SUBARU

SERVICE BULLETIN

NUMBER: 12-145-13

SUBJECT: Condensation in Rear Combination Lamps,
 Retaining Nut Change

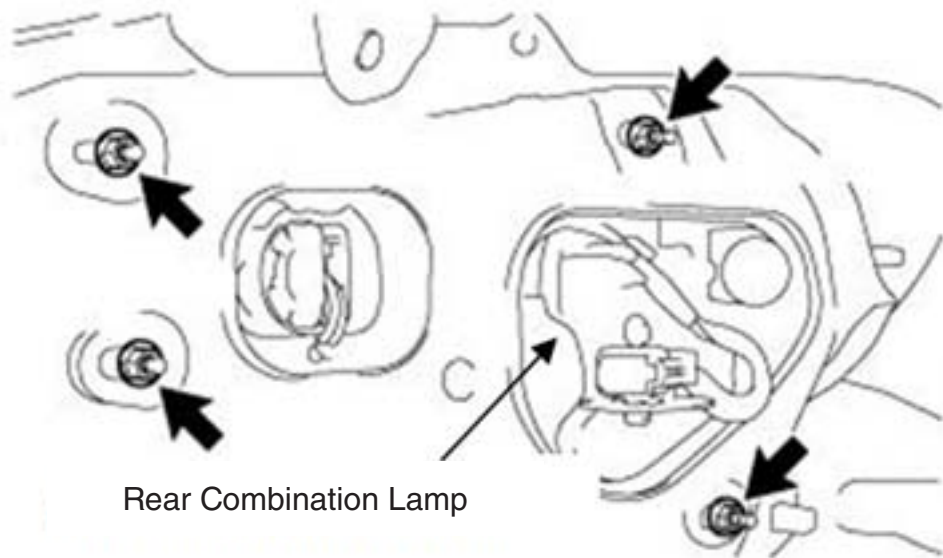
Due to a smaller diameter flange surface, the original retaining nuts may distort the rear body panel mounting and sealing surfaces for the combination lamps enough to allow moisture seepage past the seals into the combination lamps and possibly the trunk area.

Original Nut, 12mm
 diameter flange surface

Revised Nut, 15mm
 diameter flange surface

The revised retaining nuts with a larger diameter flange surface were incorporated into production starting with VIN D*605847.

DESCRIPTION	PART NUMBER
Flange Nut (each)	902370040
Packing (gasket) R/Hand	84940CA020
Packing (gasket) L/Hand	84940CA030

Example of crack

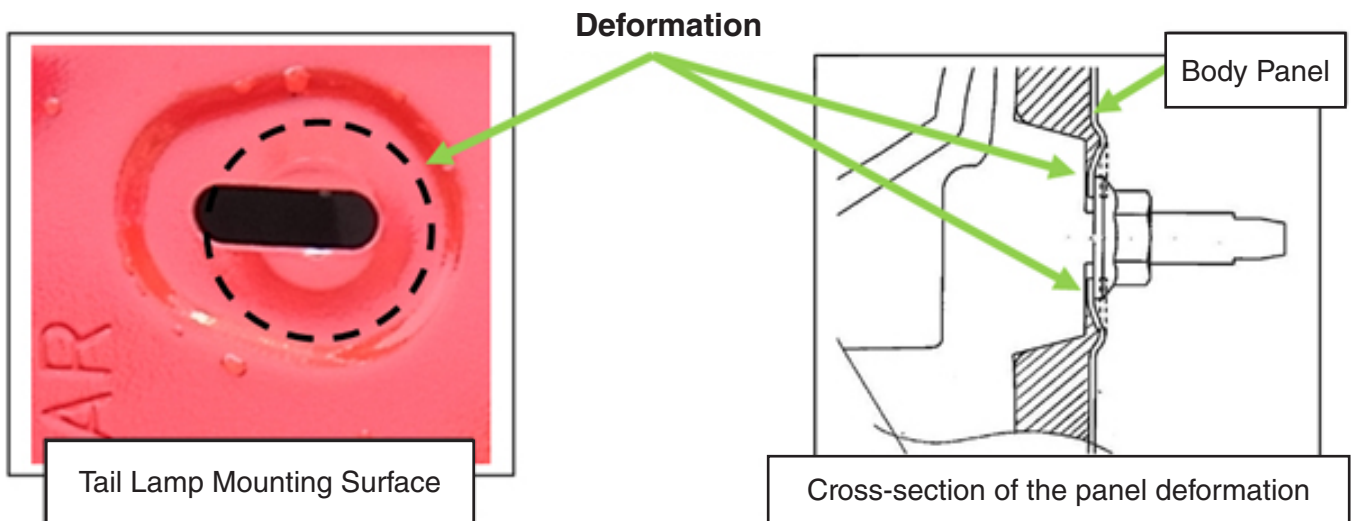
Once the combination lamps are removed, inspect their mounting stud boss areas carefully for any cracking as shown in the photo example below. Any damaged combination lamps must be replaced.

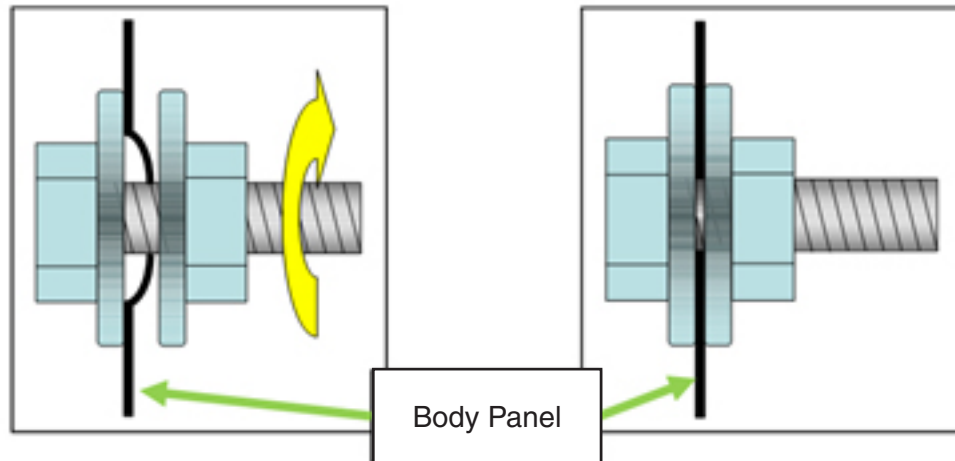
Inspect the rear body panel in the retaining nut areas for any deformation of the metal as shown in the illustrations below.

If any deformation is found, CAREFULLY straighten the affected mounting area using a small body hammer and dolly.

L/H Sequence

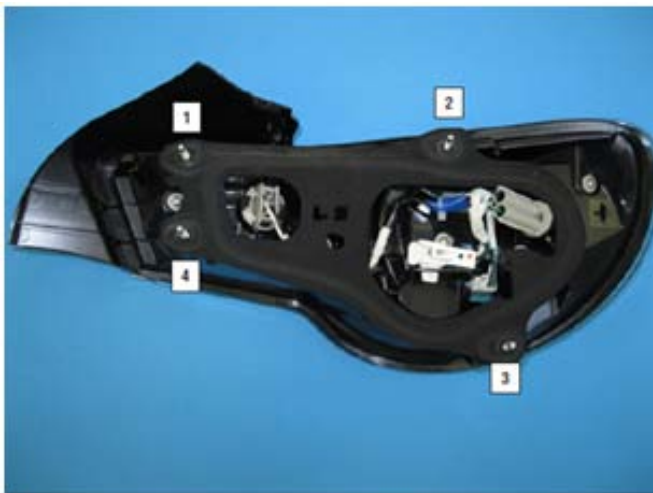
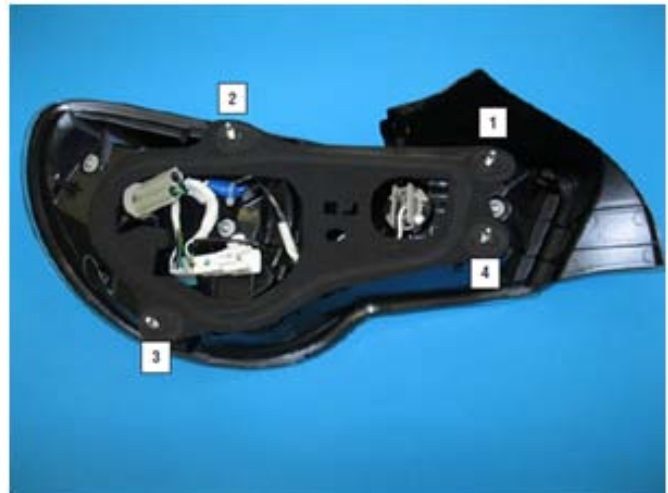
- Before reinstalling any combination lamp assembly (original or replacement), always install a new sealing gasket as they are one-time use items.
- The proper torque sequence must be followed as shown in the following illustrations or damage to the combination lamp assembly may result. The torque specification (unchanged) for the retaining nuts is 4.5 Nm (39 inch-pounds).
